Husqvarna

SB, 335 XPT, Flywheel, 1999-02

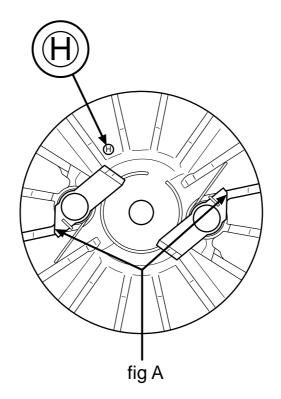
The flywheel has been modified to reduce the risk of the starter pawls slipping on the pulley during starting.

The fan blades, which act as a speed limiter for the pawls, have been adjusted so that the pawls remain nearer the centre in the rest position.

Until the corresponding modifications are made to production moulds the current flywheel will be re-machined to produce the new version. These can easily be identified by the blue marking and the fact that two of the blades have been machined. See fig. A. The new version will have production code H.
